**Attachment 3 - Summary of Amendments Proposed to Regulations on Single-Family Dwellings
in R-1 and R-1-H Single Family Residential Zones and continuation of nonconforming
structures**

DIAGRAM 10-1-603(H)(3)(D): RETAINING WALL HEIGHT WITHIN FRONT YARD

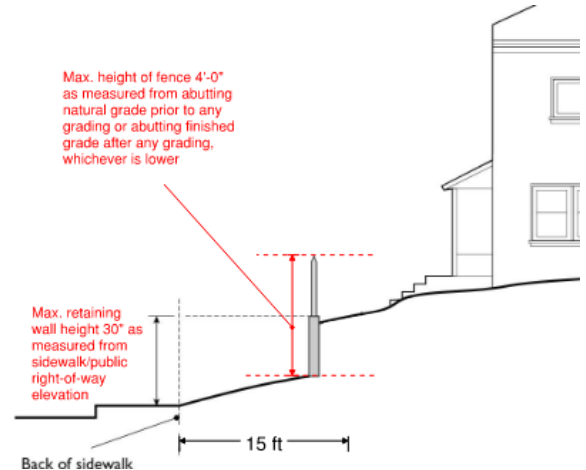
Additionally, language has been incorporated to specify a reference grade for measuring height of retaining walls located outside of the 15 feet setback as measured from the sidewalk/public right-of-way. Currently, the code does not provide details regarding reference grade for measurement of height of retaining walls located outside the 15 feet setback area, as measured from the sidewalk/public right-of-way. Retaining walls are measured the same way as regular walls. i.e., from the finished grade of the property. With this update, height of the exposed portion of retaining wall will be measured from finished grade after grading/cut/fill activity. This update facilitates consistency in measuring retaining wall height irrespective of the amount of grading. Existing regulation requiring retaining walls within 15 feet of a sidewalk to be measured from the sidewalk elevation will be maintained. Staff is proposing additional language that clarifies that in absence of sidewalks, the height of retaining walls along front or street facing side yard shall be measured from the elevation of public right-of-way. This requirement is proposed to discourage tall retaining walls that are visible from public right-of-way, in absence of a sidewalk.

Additionally, current code prohibits construction of walls on top of retaining walls within front yard setbacks. The proposed update adds language within the current code to prohibit construction of walls on top of retaining walls within street facing side yard setbacks as well. This requirement has been included to prevent construction of fortress like walls along street facing side yards. Other proposed updates include permitting replacement of damaged legal non-conforming retaining walls to previous height and location if a City official determines it to be unsafe. This update has been included to provide flexibility to rebuild legal retaining walls to previous permitted height.

~~abutting ground surface prior to grading.~~ Walls shall not be placed above retaining walls **within the front yard setback and street facing side yard setback.**

e. Additional retaining walls must be setback a distance equivalent to twice the height of the **exposed retaining wall below as measured from the face of the retaining wall below lowest abutting finished ground surface, after any grading, cut, or fill activity.**
